M&A 3575-1

RE: Headquarters Road Bridge

Figure 2 - **PROPOSED REPLACEMENT SECTION** by PENNDOT

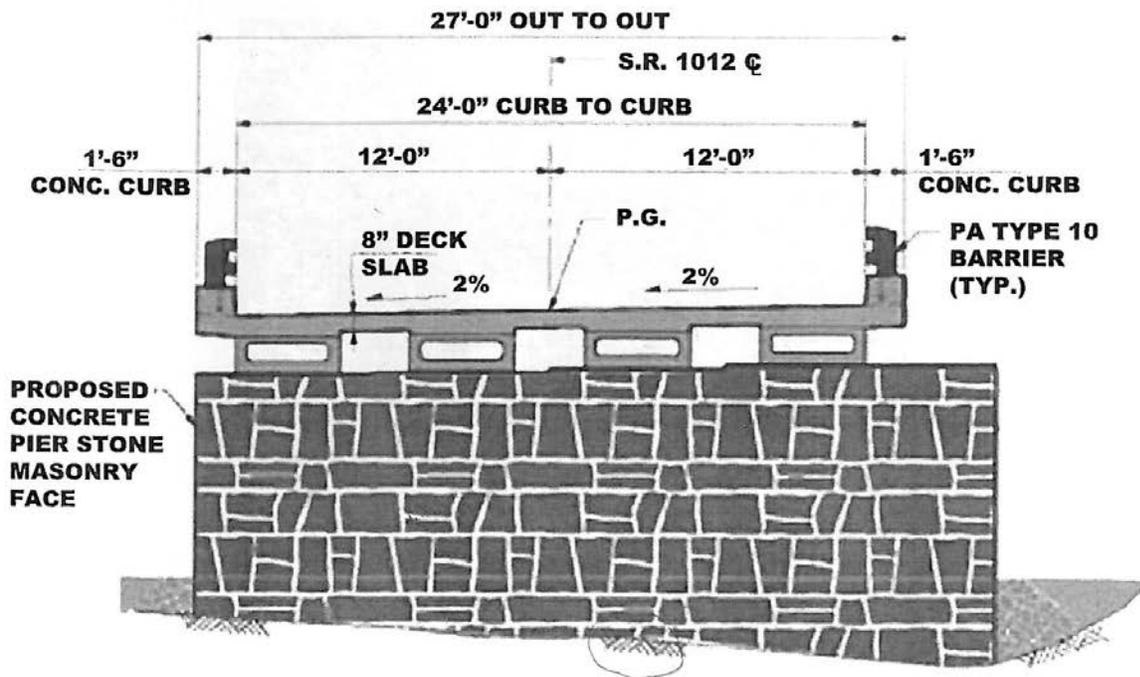
We reviewed the April 27, 2011 Public Plans proposed by PennDot for the **Replacement** of the bridge as prepared by Urban Engineering, Inc. These plans contain several elements that are in direct conflict with the Secretary's Standards as follows:

1. The proposed replacement of the existing stone piers, abutments and walls with new reinforced concrete construction with fake stone masonry facing does not meet the Secretary of Interior Standards. The Standards state "...changes that create a false sense of historical development, such as adding conjectural features or elements from other historic properties, will not be undertaken."

2. The proposed replacement of the existing steel and concrete deck superstructure with precast concrete box beams is contrary to the Secretary of Interior's Standards "...Where the severity of deterioration requires replacement of a distinctive feature, the new feature will match the old in design, color, texture and, where possible, materials."

3. The proposed width of the bridge roadway of 24 feet drastically changes the character of the span and does not comply with the Secretary's standard "...The historic character of a property will be retained and preserved. The removal of distinctive materials or alteration of features, spaces and spatial relationships that characterize a property will be avoided."
